AMENDMENTS TO THE DRAWINGS

REMARKS

Fig. 4

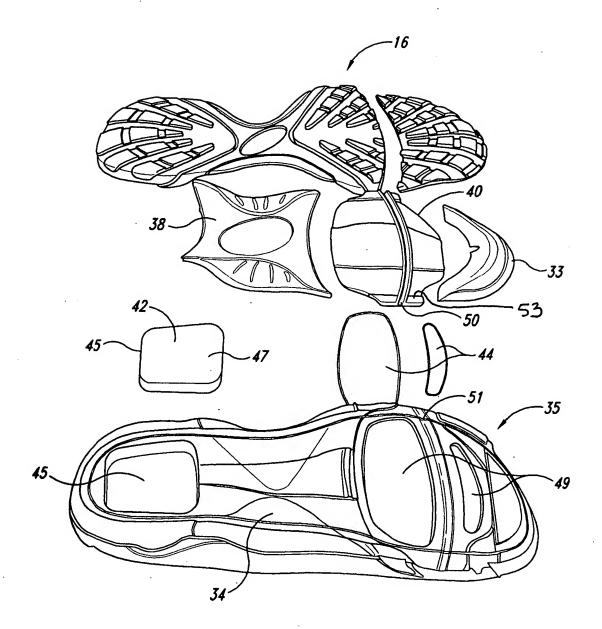
In the Office Action, the Examiner objected to the drawings in view of the outer stiffening rib set forth in claim 15. Applicant has revised Figure 4 to add reference number 53 showing the outer stiffening rib. No new matter has been added. Applicant has included redline copy of Figure 4 showing the change is enclosed for the Examiner's convenience. A replacement sheet showing revised Figure 4 is also enclosed. Paragraph 0029 of the specification has also been amended to add reference number 53. In view of the amendment to Figure 4 and the specification, Applicant respectfully submits that the objection to the drawings has been overcome.

Please amend Figure 4 as shown in the replacement sheet filed herewith. A redline copy of Figure 4 showing the changes is enclosed for the Examiner's convenience.
